THE STATE OF NEW HAMPSHIRE
DEPARTMENT OF TRANSPORTATION

Highway Design Manual
October 2023

Appendix 11-02

Subject: Recreation Trails under State Highways

SECTION A-A
 SCALE: 1/4" = 1'-0"

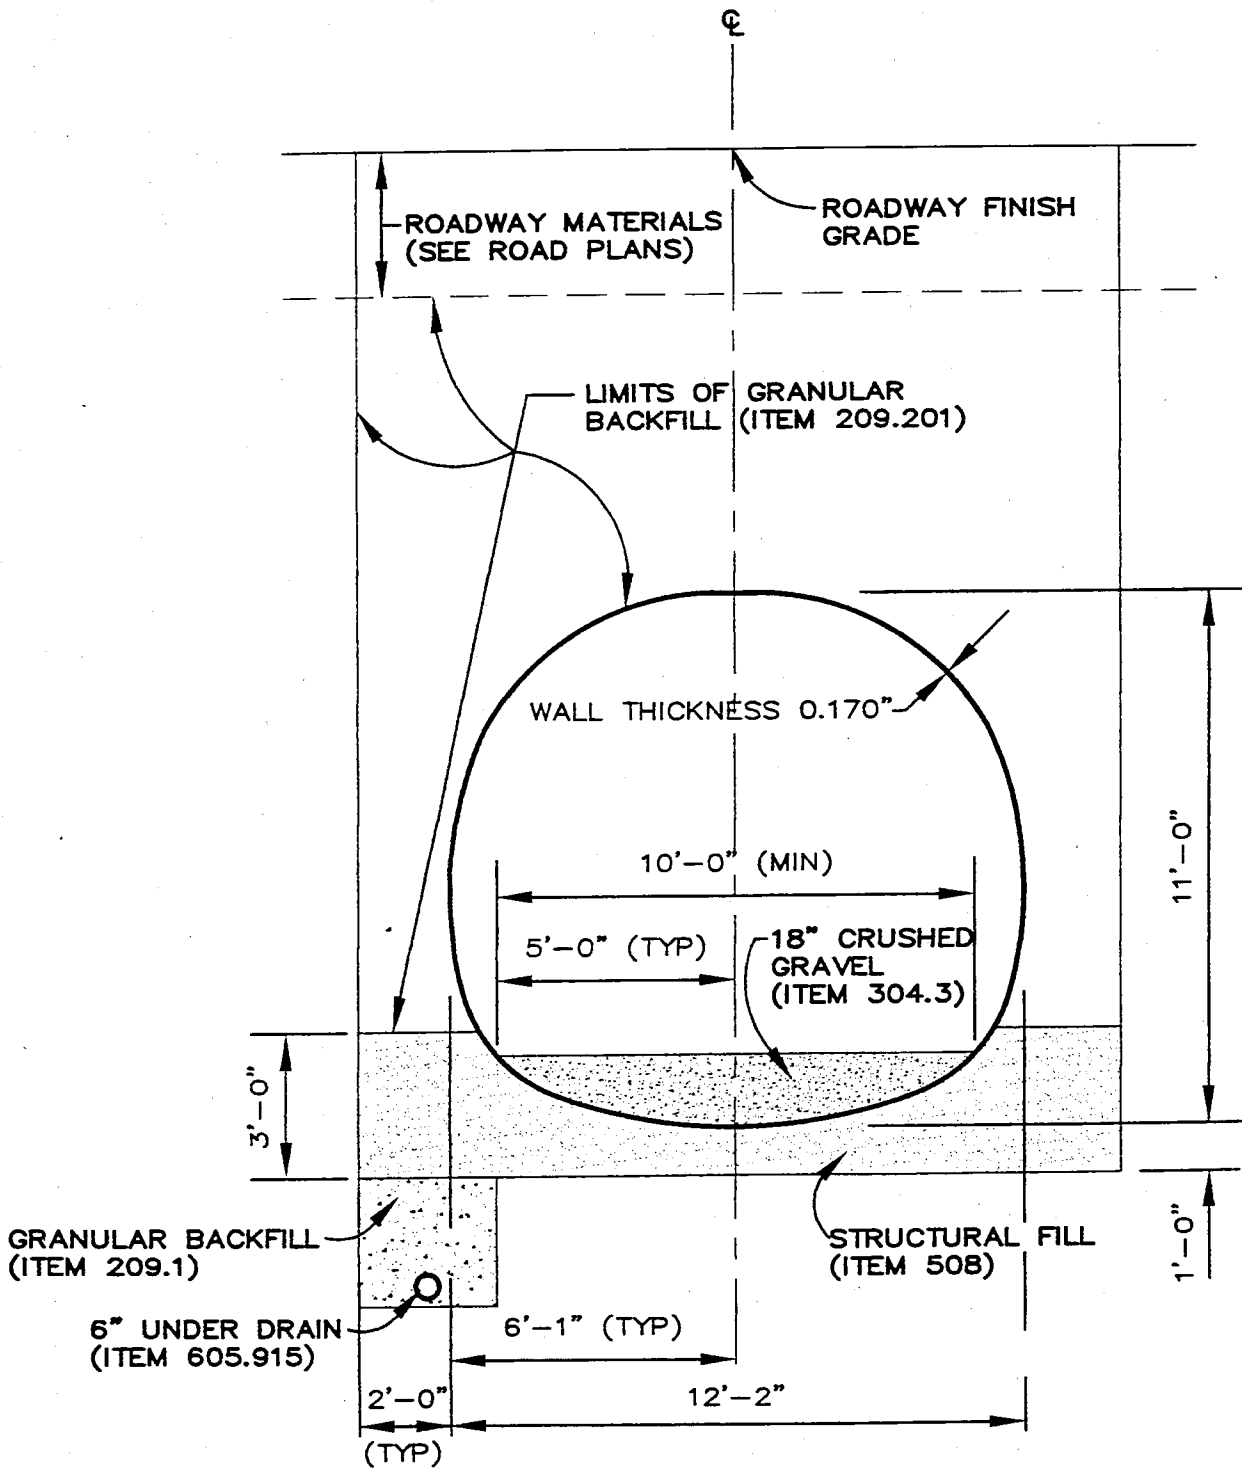
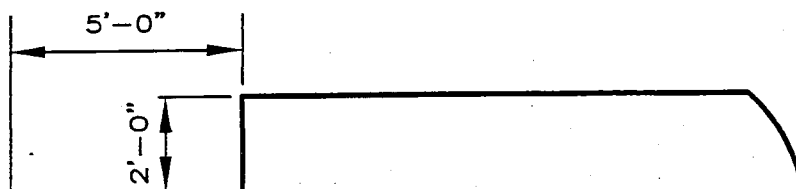
It has been brought to my attention that the design "standard" that DOT is using for structural plate pipe arches needs to be changed. The pipe arches are being installed to permit trail users to go under state highways. The reason for the change is that the current design restricts the choices of grooming equipment that the clubs will be able to use to groom the trail corridors, which include the old rail corridors the state (DOT) has recently been purchasing and turning over to the Bureau of Trails for recreation use.

The full size groomers that the clubs in the north country are currently buying are very close to being 10 feet square(with lights and brush bars). While the current tube size is adequate for the southern portion of the state, it is inadequate for the north country.

Under most applications the snowmobile underpass which we are currently using is acceptable (copy attached). In some circumstances it may be desirable to increase the size of the underpass to meet the needs of a particular trail. A request by your Department to increase the size will be incorporated into our project unless its incorporation creates a significant design problem or increases the cost of our project significantly. Each project involving a snowmobile underpass will be reviewed with your Department early in the design phase to address the underpass size as well as other issues regarding the snowmobile trail.

TRAIL PLAN

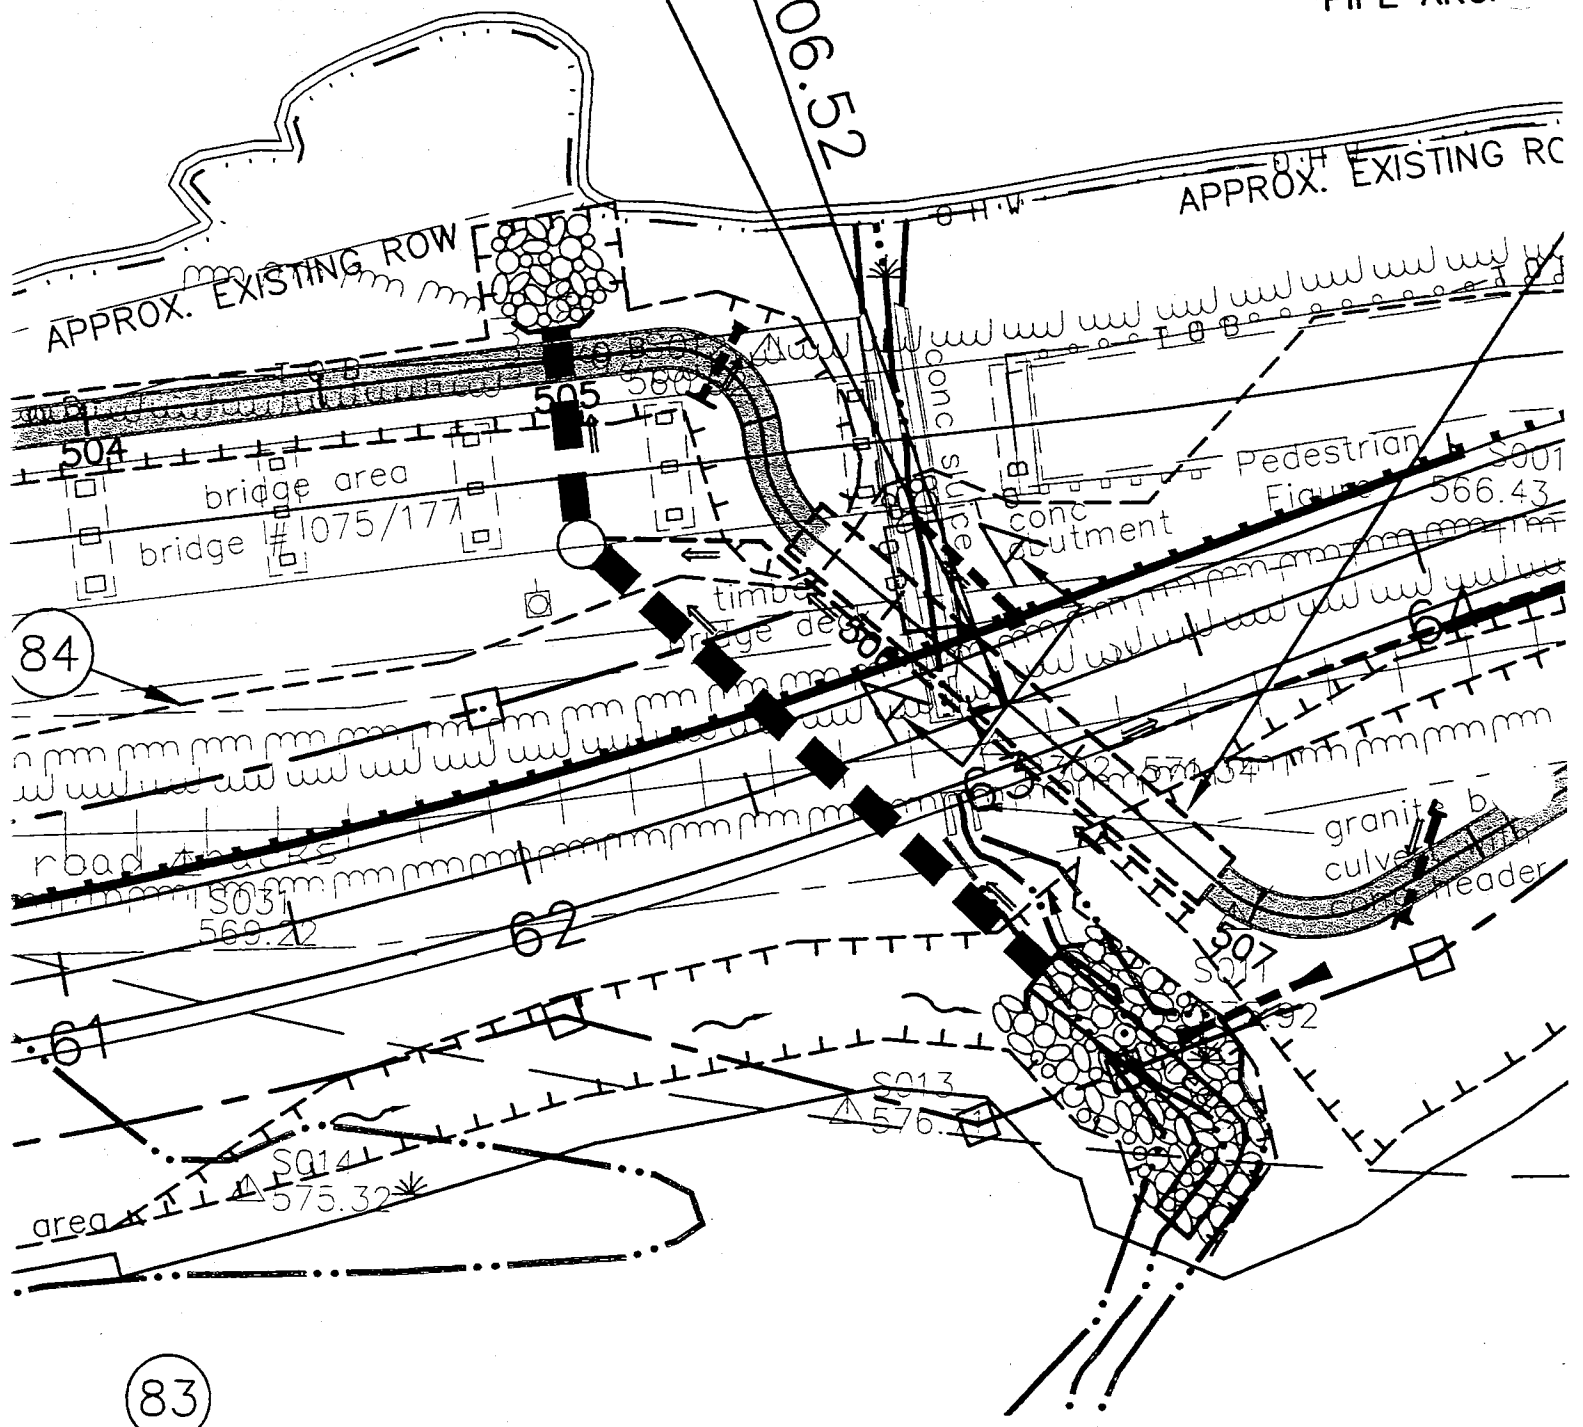
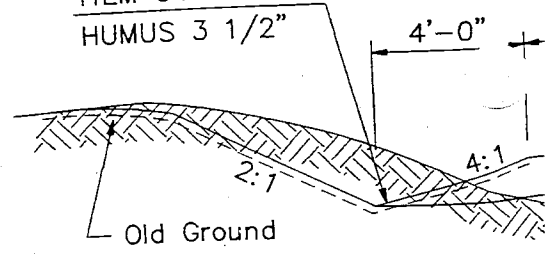
c. Construct the pipe as proposed but flatten out the highway side slopes to be 4:1 on the west side of the highway so as to be traversible by a grader. The grader would then leave the trail and ride along the highway crossing over the highway in the area of Sta 61+00. This requires a break in the proposed guard rail and some add'l fill material to flatten the side slopes. The trail immediately adjacent to the underpass would need to be groomed by another method.

SECTION A-A

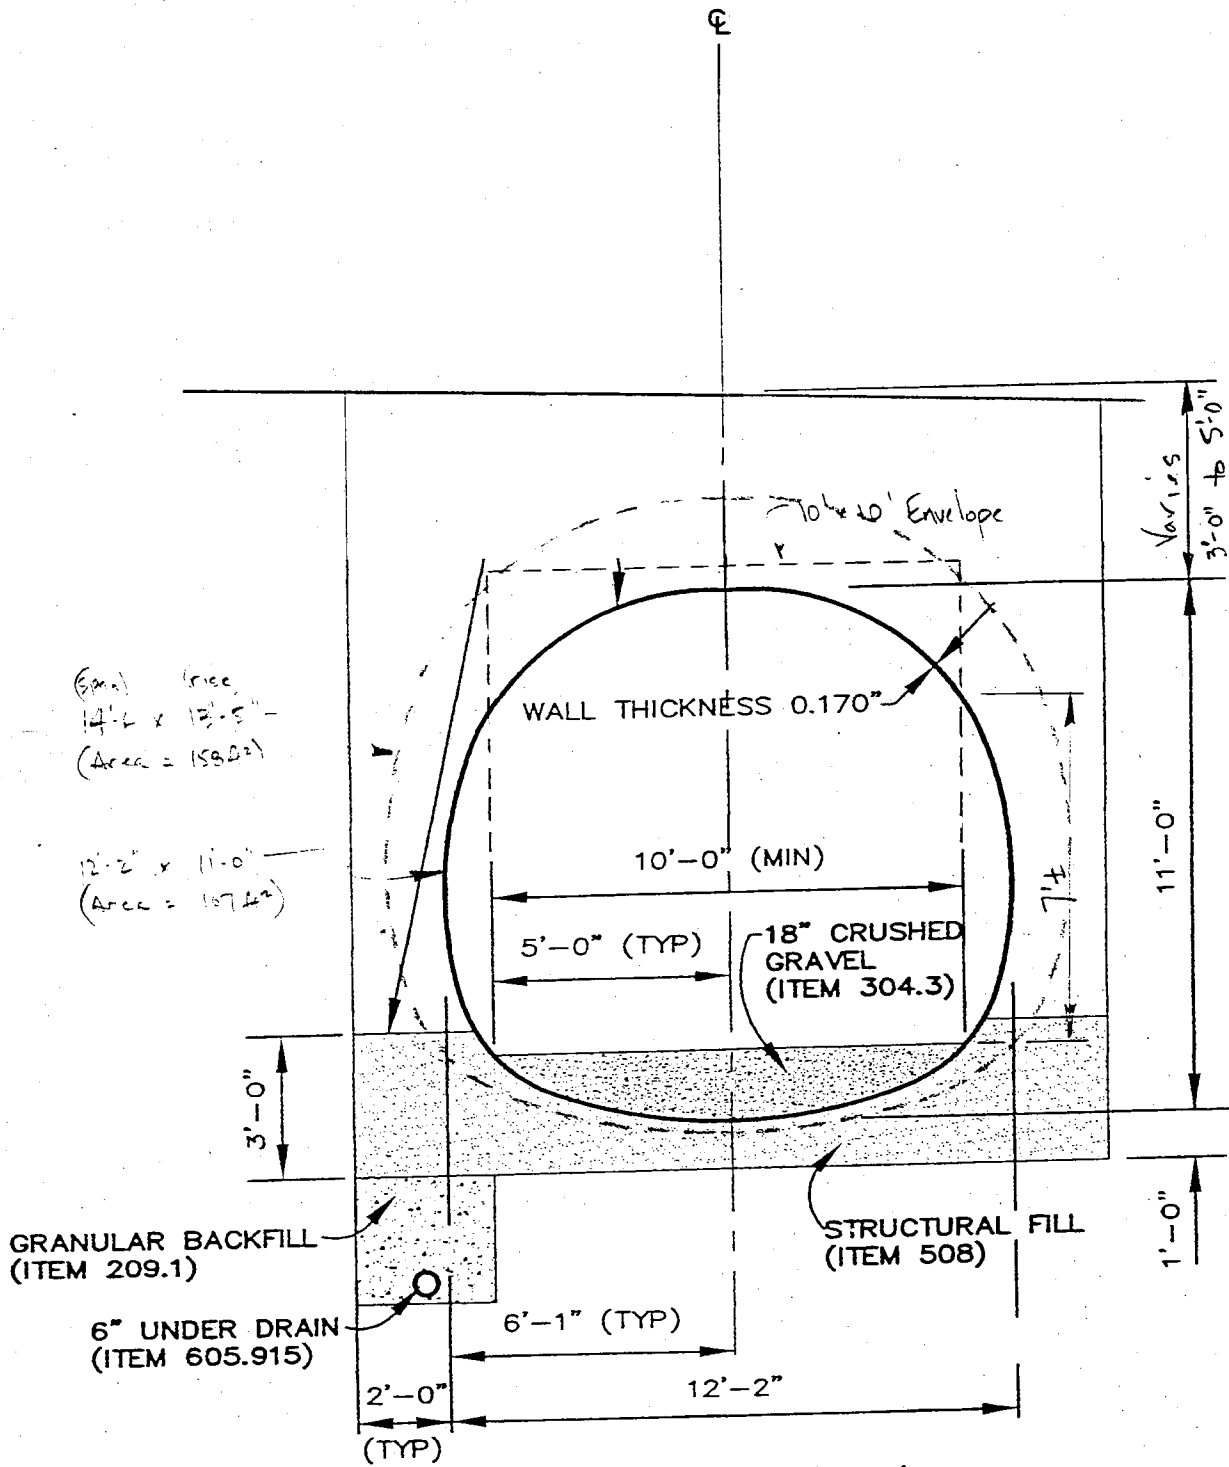
(Sp. Area) Area
 14'-2" x 12'-5"
 (Area = 158.02)

12'-2" x 11'-0"
 (Area = 134.2)

1. Communication with Trails for the Landoff project has been adequate, consisting of a telephone conversation explaining that the proposed underpass is in keeping with AHDOT practice.
2. Originally the trail crossing was proposed to be at grade. In light of the trail, an underpass was investigated and found to work using the standard pipe section. The pipe was located so that the future ramp to the future Lubon bypass could utilize the same pipe in the same location. The location also minimized wetland impacts. The location was marginal in terms of providing proper cover over the pipe. The cover on the east (uphill) end of the pipe is near the minimum, but is acceptable.
3. Alternatives to the proposed design include:
 - a. Construct a concrete box culvert with 10'x10' opening in the location currently proposed for the underpass. A delay in advertising is likely, but it can probably

b. Construct a new pipe with opening sufficient for a 10' x 10' envelope to the south. This will increase EOW impacts, wetland impacts, and more extensive delays in design.
